PLANNING COMMISSION AGENDA
August 8, 2023 – 5:30 PM

Memo Date: August 1, 2023
Meeting Date: August 8, 2023
To: Newport Planning Commission
From: Nathan Fuerst, AICP, City Planner
Subject: Preliminary & Final Plat and PUD Review – Red Rock Square II

Subject: Red Rock Square II – Plan Review

TREE PRESERVATION PLAN

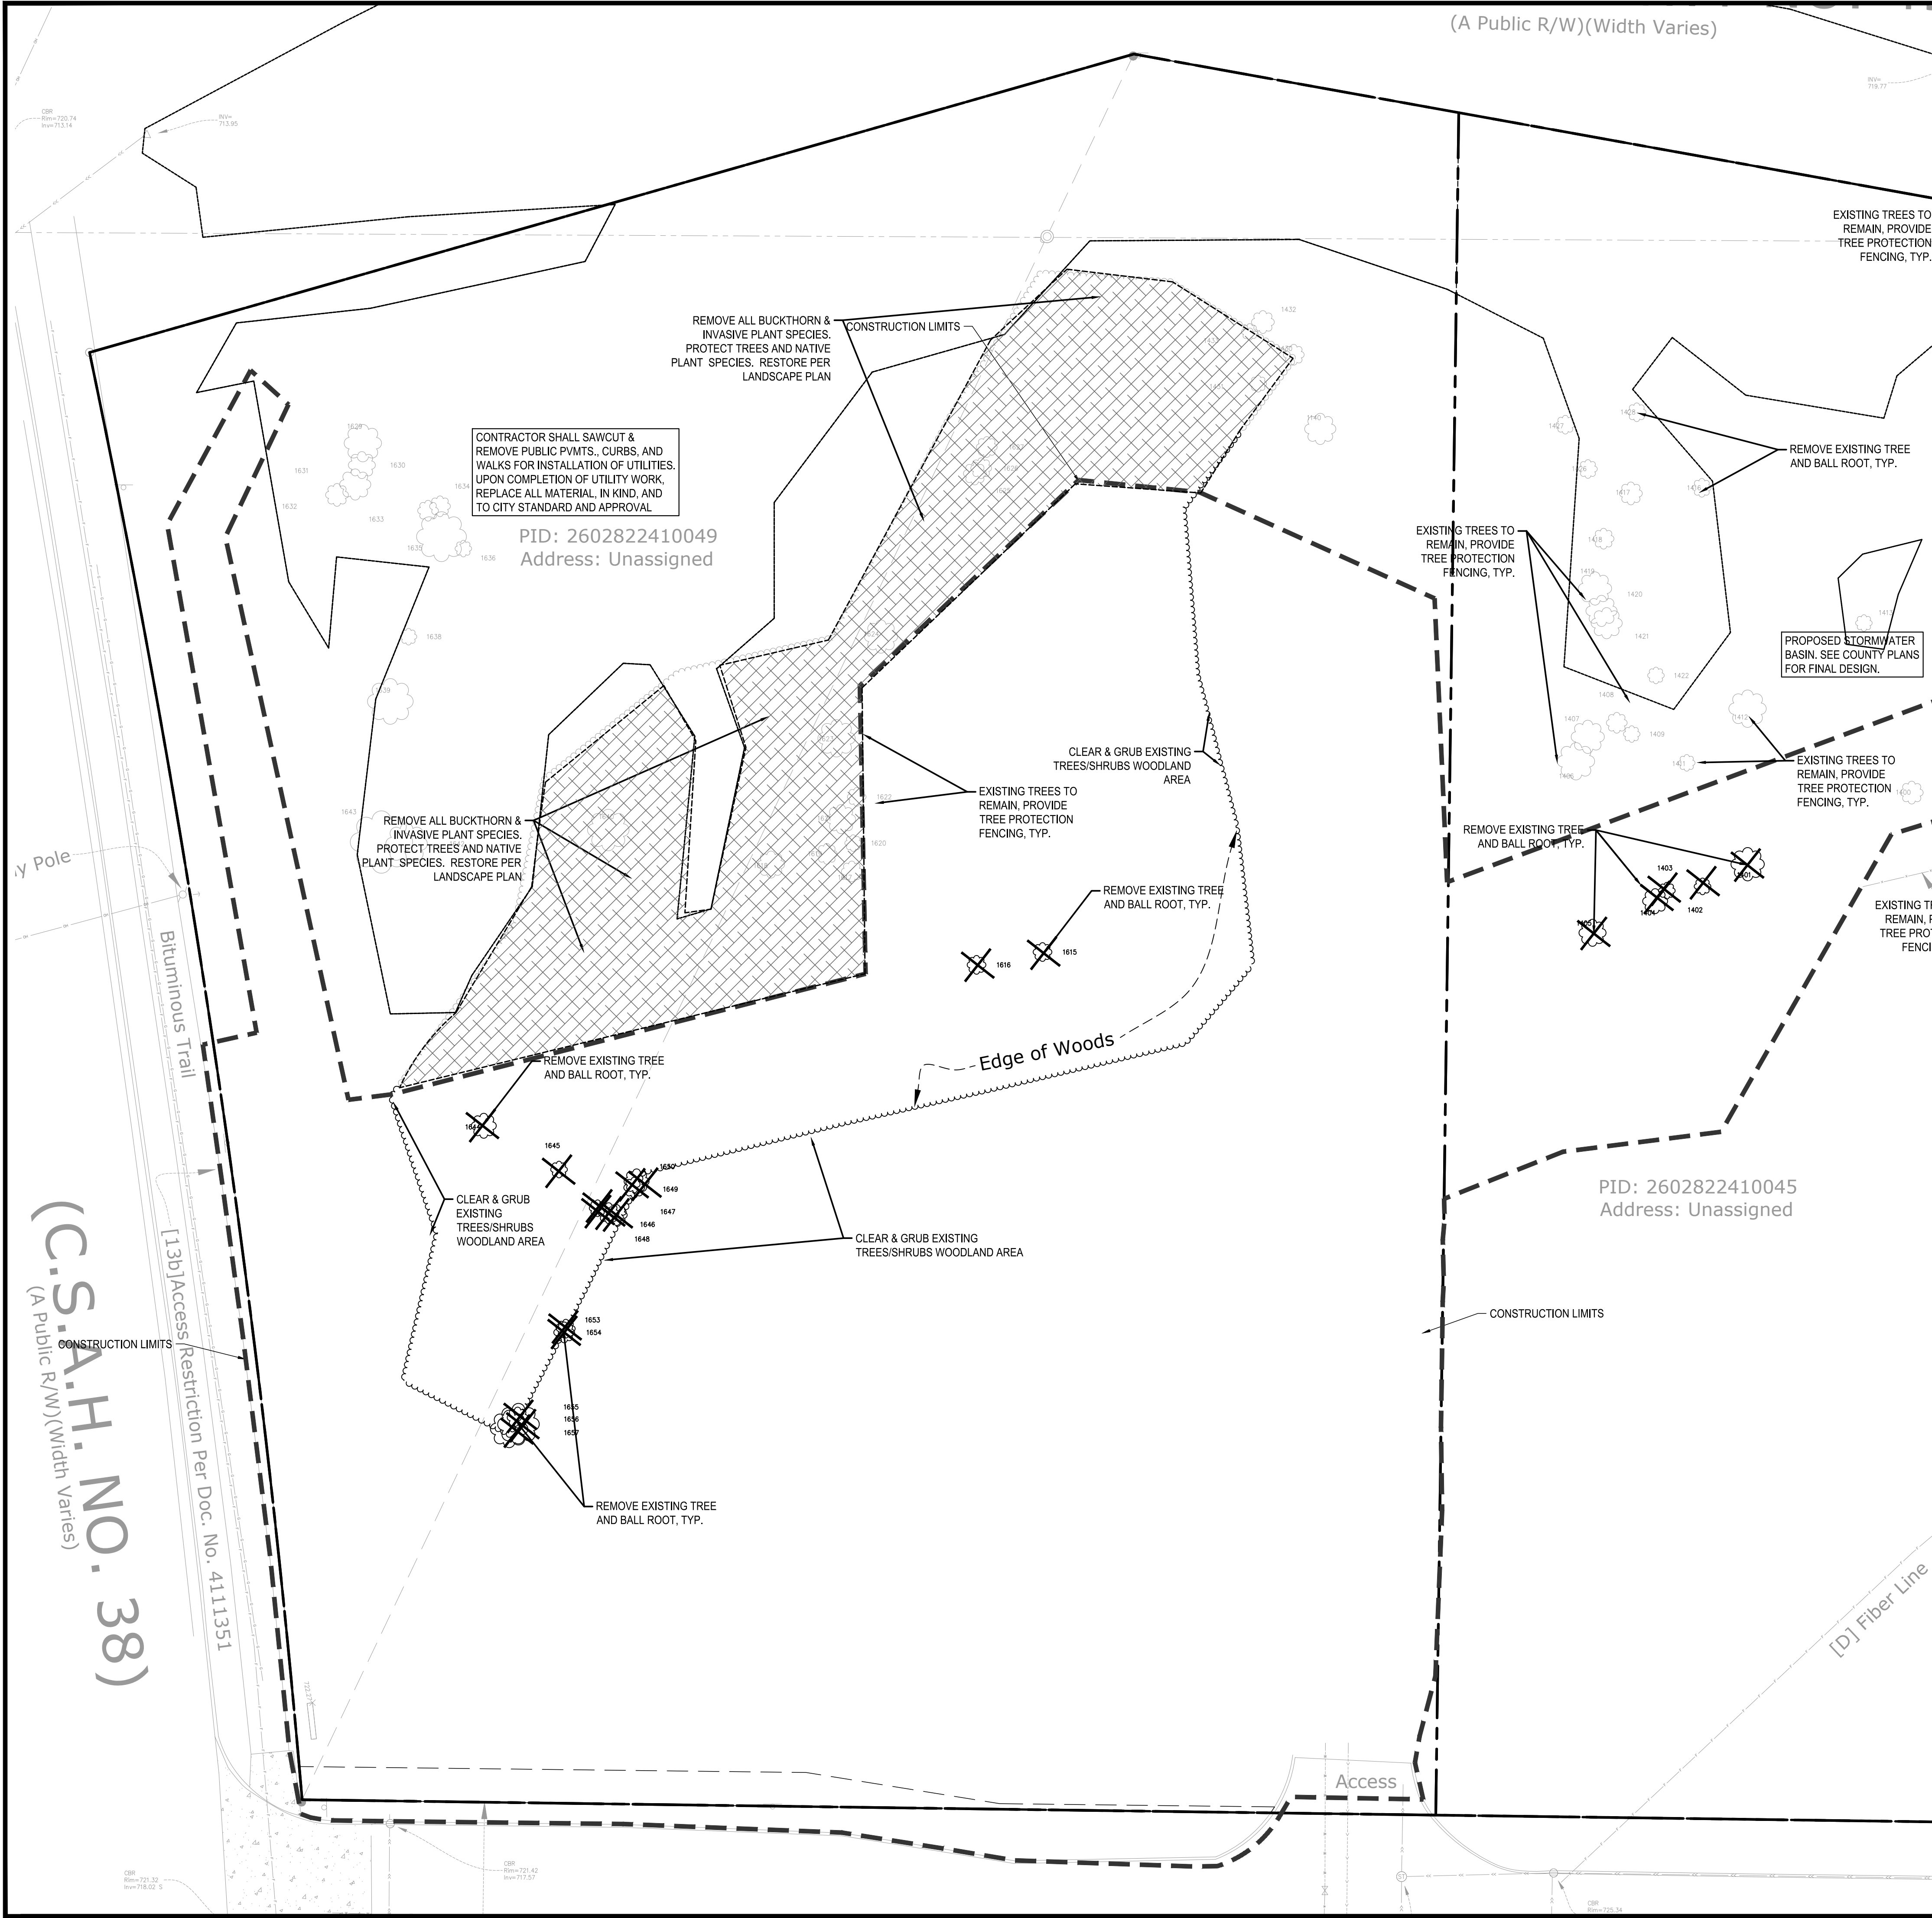
A tree preservation plan, meeting the requirements of City Code Section 18-42 was submitted and reviewed by staff. The Developer is removing 17 softwood trees which qualify as significant trees. After allowed removals, the Developer is required to provide an additional 9.3 trees. This was identified in the landscaping plans and suitable replacement trees are provided in the landscaping plan to address the mitigation requirement.

Staff note that several plantings are shown to remain close to the proposed grading limits. It is possible that incidental tree loss could occur if grading or construction activities impair the critical root zone of existing trees. Therefore, staff is recommending a condition of approval requiring inspection of the trees and revision of the tree mitigation plan if any incidental loss occurs.

9. Any incidental loss of existing trees through grading or construction activities will necessitate revision of the tree mitigation plan, and if additional mitigation is required, a cash in lieu fee shall be paid by the Developer.
